ADDENDUM NO. 1

PROJECT NAME: **HARDBERGER PARK PHASE V TRAILS**

DATE: 7/14/2015

TCI PROJECT NO.: **23-01451**

BURY	
STORM WATER POLLUTION PREVENTION PLAN	
100% CONSTRUCTION DOCUMENTS	
PHIL HARDBERGER PARK	
8400 NW MILITARY HIGHWAY SAN ANTONIO, TEXAS 78230	
DATE: 07/14/15 SHEET: LC1.04	DRAWN BY: JM, KR DESIGNED BY: DB, JM QA/QC: DB, JN PROJECT NO.: 04100796-00006
APPROVAL:	REVISION:

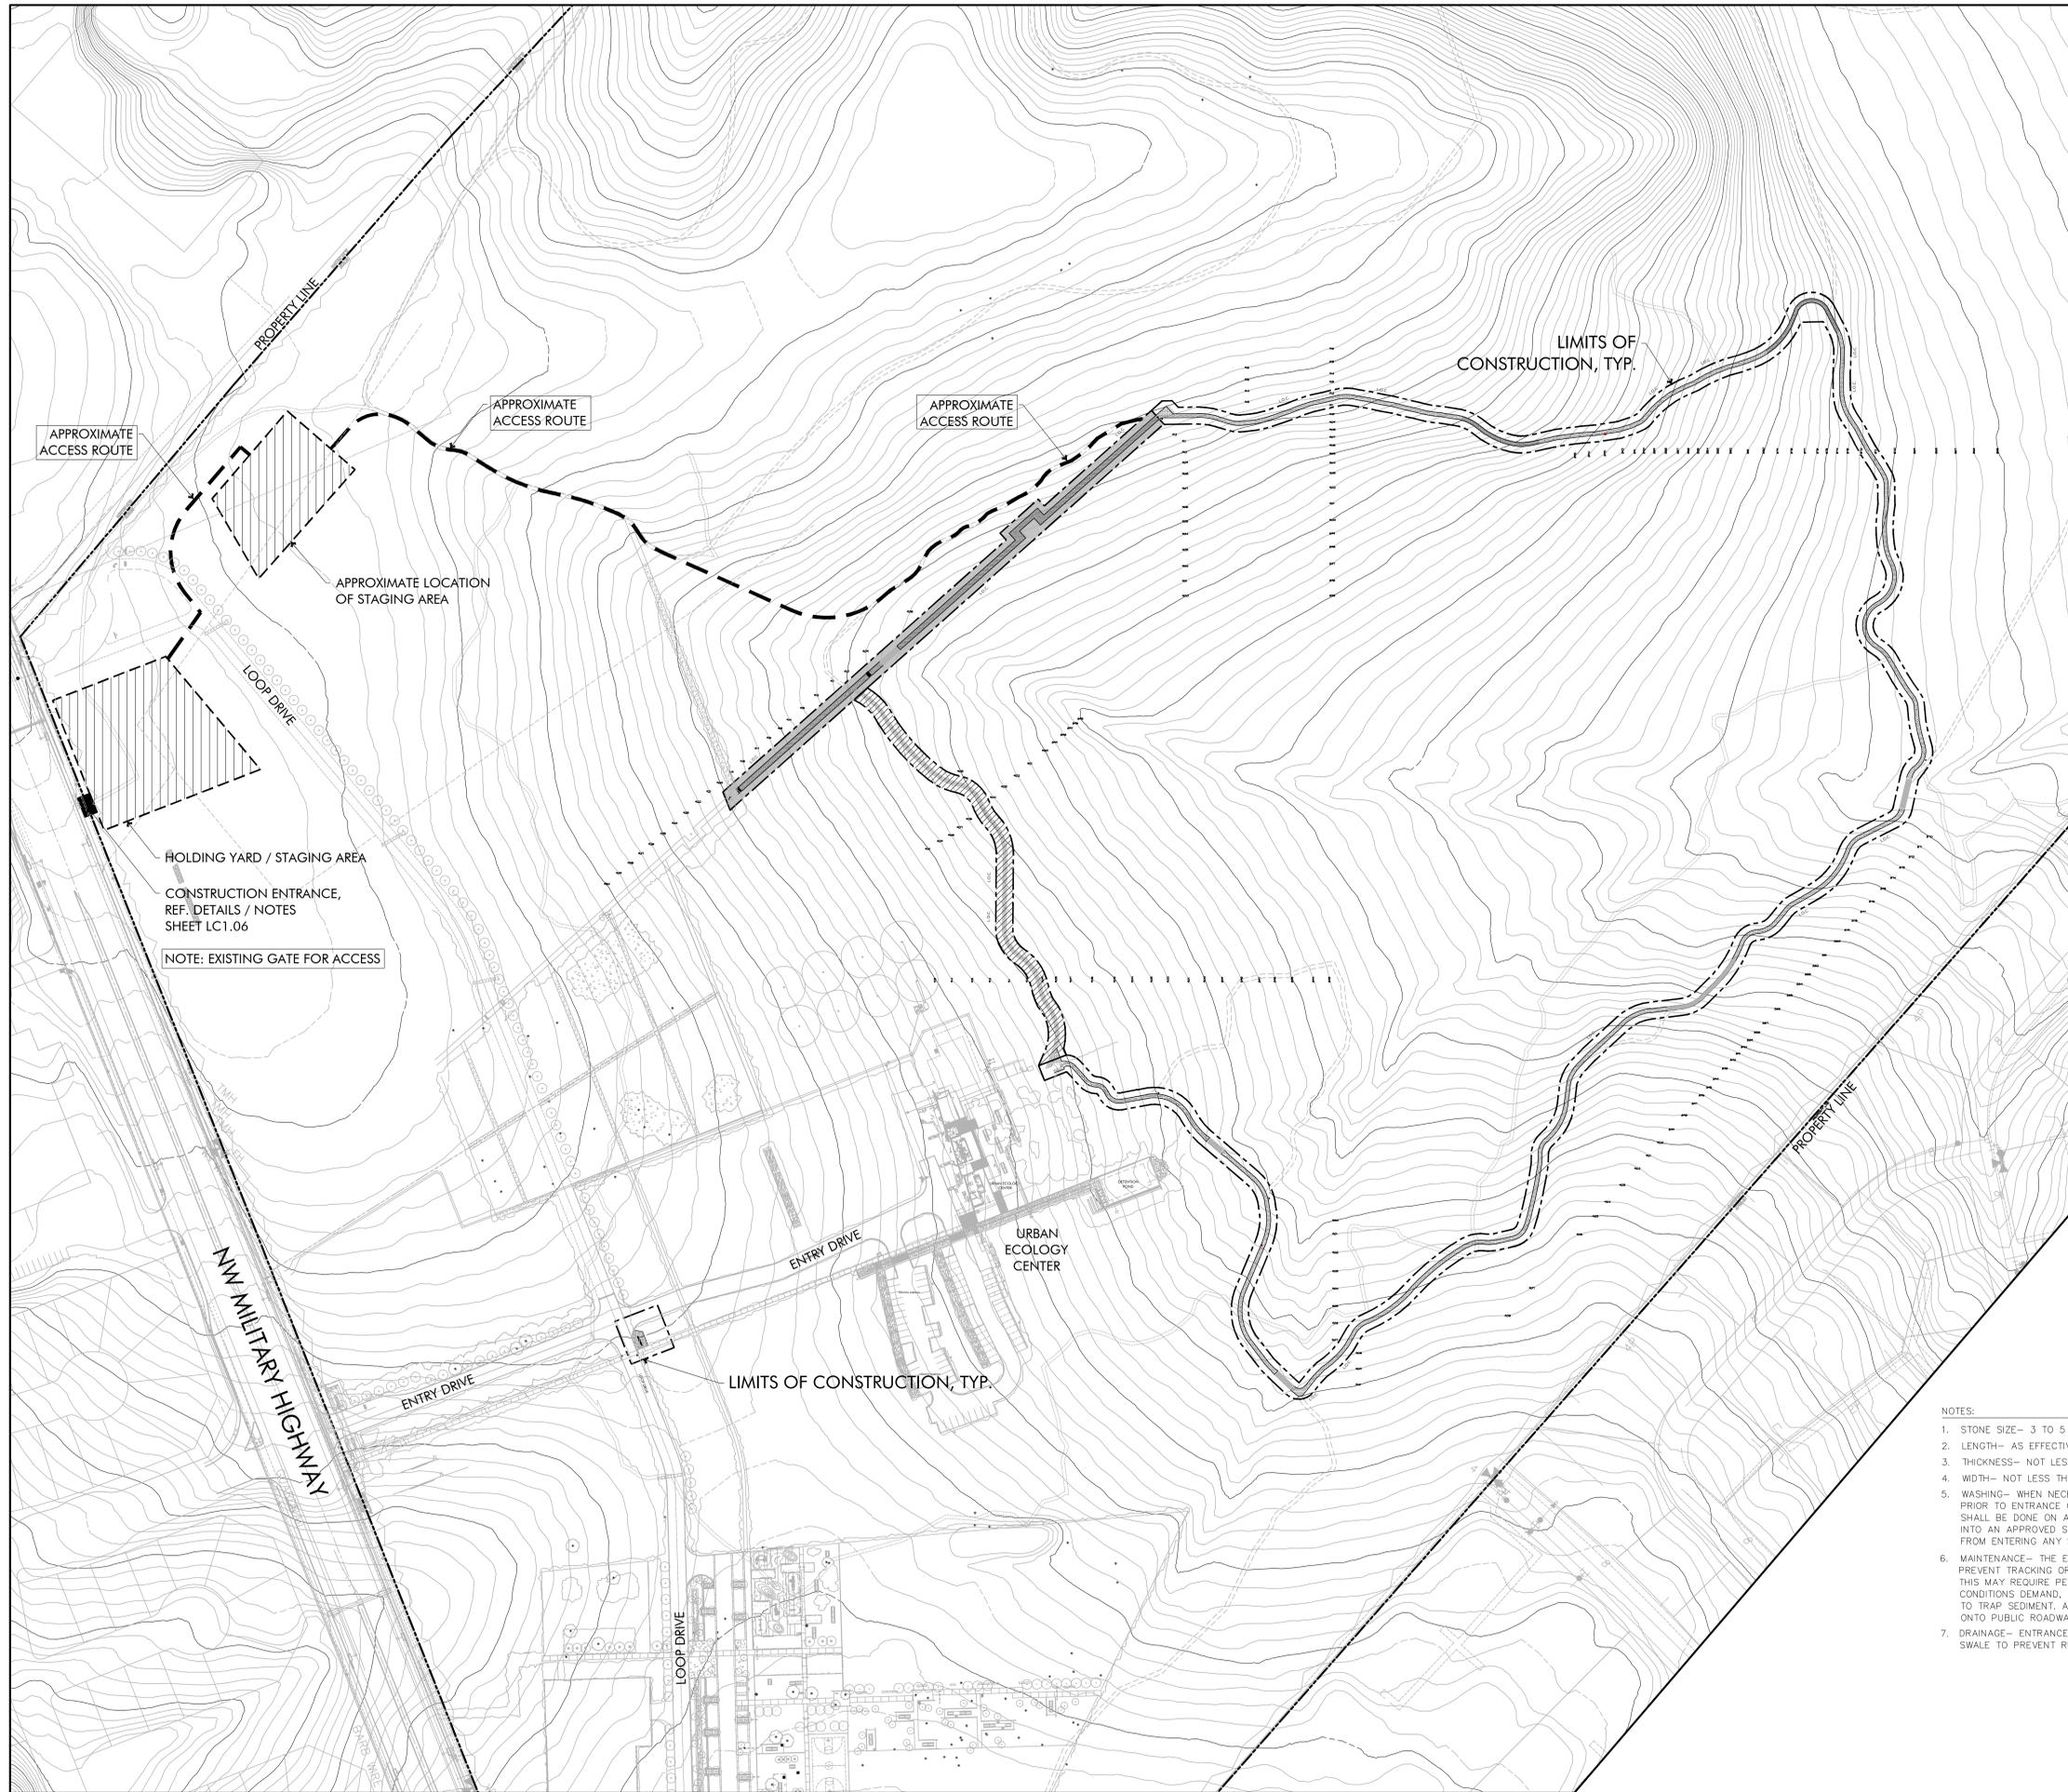
- ITEM NO. 6: SHEET LC1.04, STORM WATER POLLUTION PREVENTION PLAN
A. New sheet.
- ITEM NO. 7: SHEET LC1.05, STORM WATER POLLUTION PREVENTION PLAN
DETAILS
A. New sheet.
- ITEM NO. 8: SHEET LC1.06, CONSTRUCTION STAGING AND ACCESS PLAN
A. New sheet.
- ITEM NO. 9: SHEET LH1.04, HARDSCAPE AND GRADING PLAN
A. Note added showing approximate limits of native seed mix around sign.
B. Note added to relocate existing P&R Rules sign
- ITEM NO. 9: SHEET LH3.02, HARDSCAPE DETAILS
A. Sheet reviewed and sealed by a Structural Engineer to provide clarification
for items, reinforcing steel.
- ITEM NO. 10: SHEET LH3.03, HARDSCAPE DETAILS
A. Detail 1 – weathering steel clarification provided.
B. Detail 2 – approximate limits of seed mix added to detail.
C. Detail 4 – Construction Project Sign added.
